ADDENDUM 1

Reference: First Floor Remodel – Student Service Center – Phase II
Weber State University – Ogden, Utah
DFCM Project No. 07349810

ADDENDUM NO. 1 Phase II

Weber State University
Phase II
Student Services First Floor Remodel
Ogden, Utah
DFCM Project No. 07349810

**#1
DRAWING**

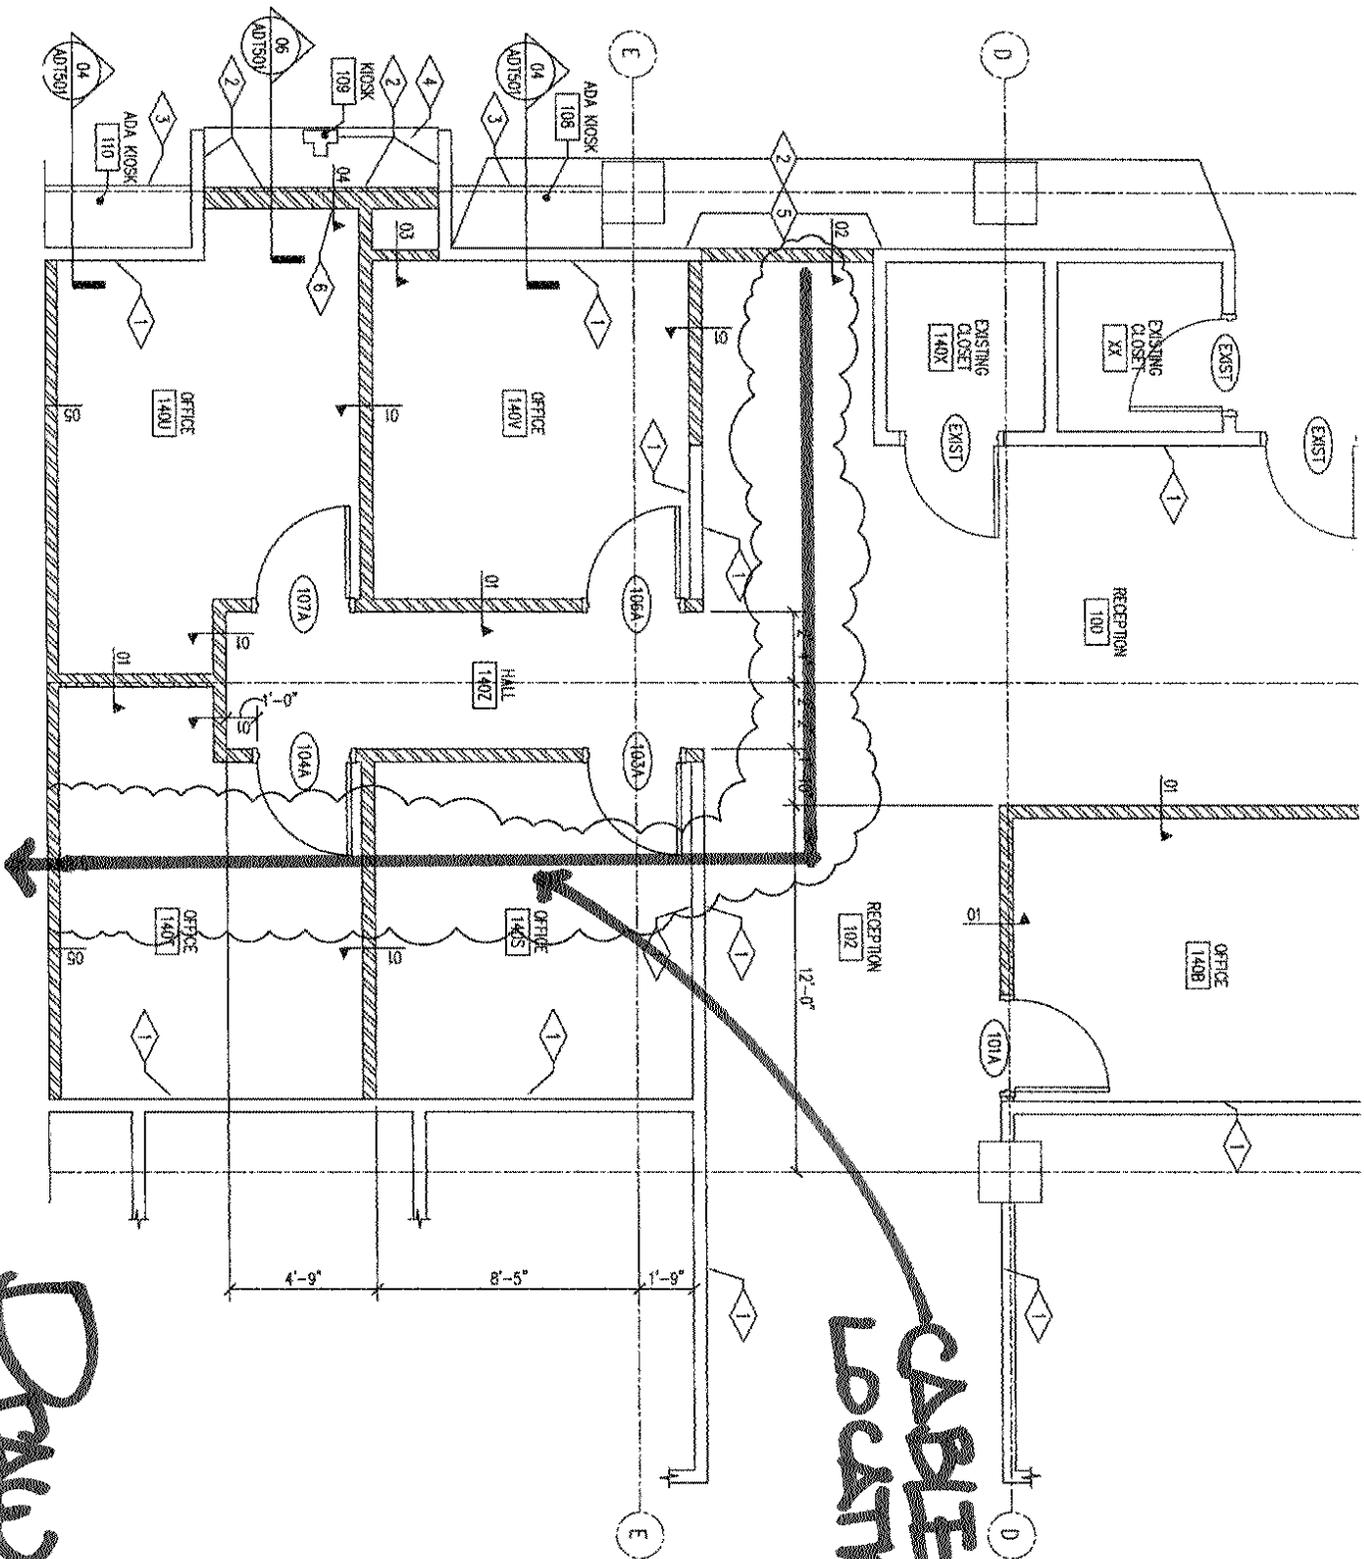
1. See attached drawing No1 indicating cable tray location. General contractor shall provide data/phone outlet boxes and conduits at locations as shown on electrical drawings. Communications conduits shall be run from data/phone boxes in walls and above ceiling and terminated at a point within 1'-0" of new cable tray location. New cable tray is not part of phase II construction.
2. The owner will be providing new rubber base in the following rooms:
 - a. RECEPTION 100
 - b. OFFICE 101
 - c. RECEPTION 102
 - d. OFFICE 103
 - e. OFFICE 104
 - f. HALL 105
 - g. OFFICE 106
 - h. OFFICE 107.
